**E4419B-17A**

**S E R V I C E N O T E**

**Agilent E4419B EPM Average Power Meter**

**Front Panel Display Problems Caused by Power Assembly Cable**

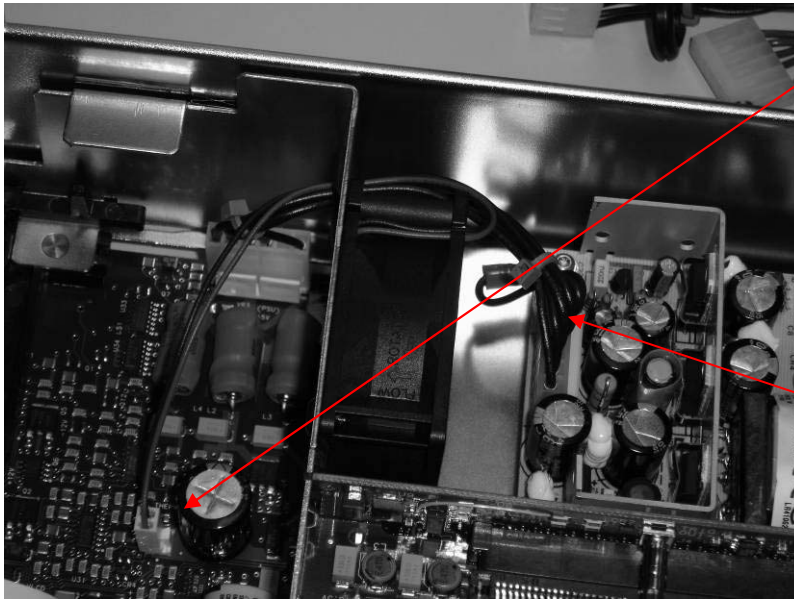
- 3) Remove fan connector and PSU cable assembly and replace with new PSU cable assembly E4418-61005. You can differentiate the cable assembly by the colors. The old cable is Black and new cable is RED.

Fan connector

PSU cable New cable is RED in color

Insert the plastic casing horizontally

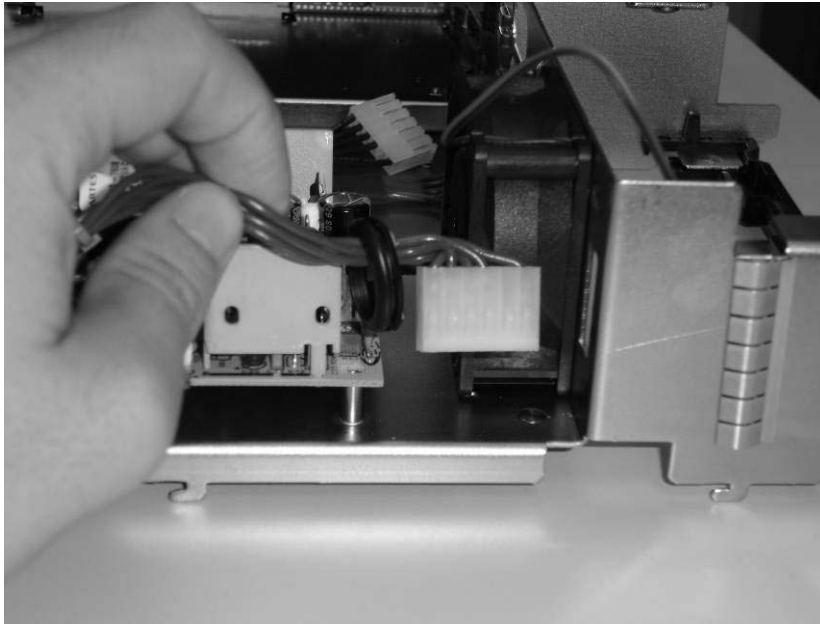
- 5) Here are some tips regarding the new cable. Since the plastic casing is slightly bigger in size, so you cannot directly pass through connector through hole. So you need to insert the cable horizontally. See illustration below.

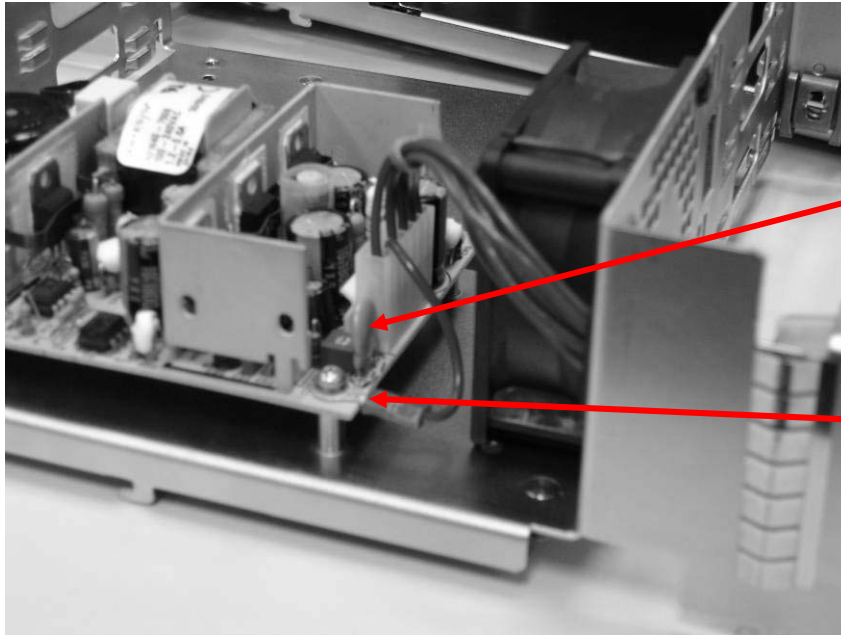
7) Photo below show different of old and new cable. The new cable is red in color whereas the old cable is black in color. The E4418-61005 has 1 ground wire.

New cable assembly

Old cable assembly

Note: If the power cable assembly is red in color, indicates that the cable already been changed. No action is needed.

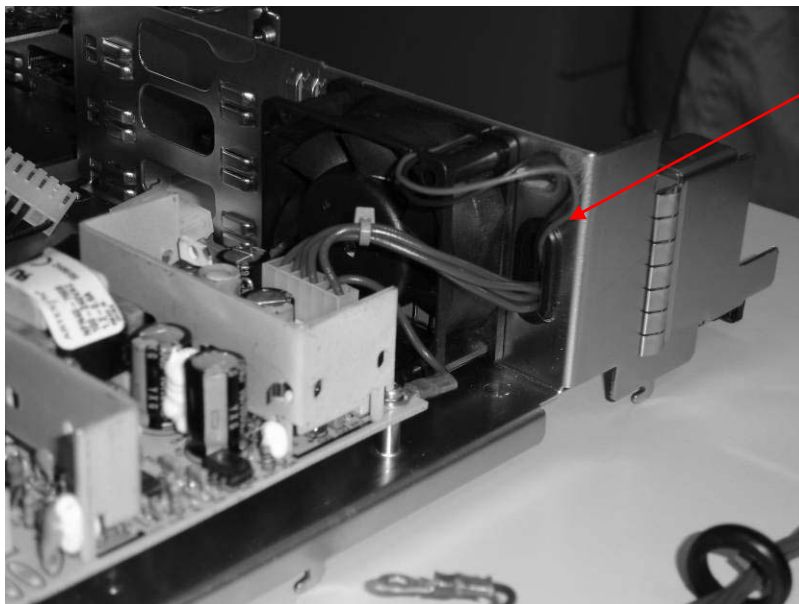
Yellow Capacitor.

Ground wire connected to PCB

10) This picture above shows the ground wire connection to the PCB. Please be aware that the ground connection is very close to the leg of the yellow capacitor. PLEASE DO NOT LET THE GROUND WIRE TOUCHES THE CAPASITOR'S LEG.
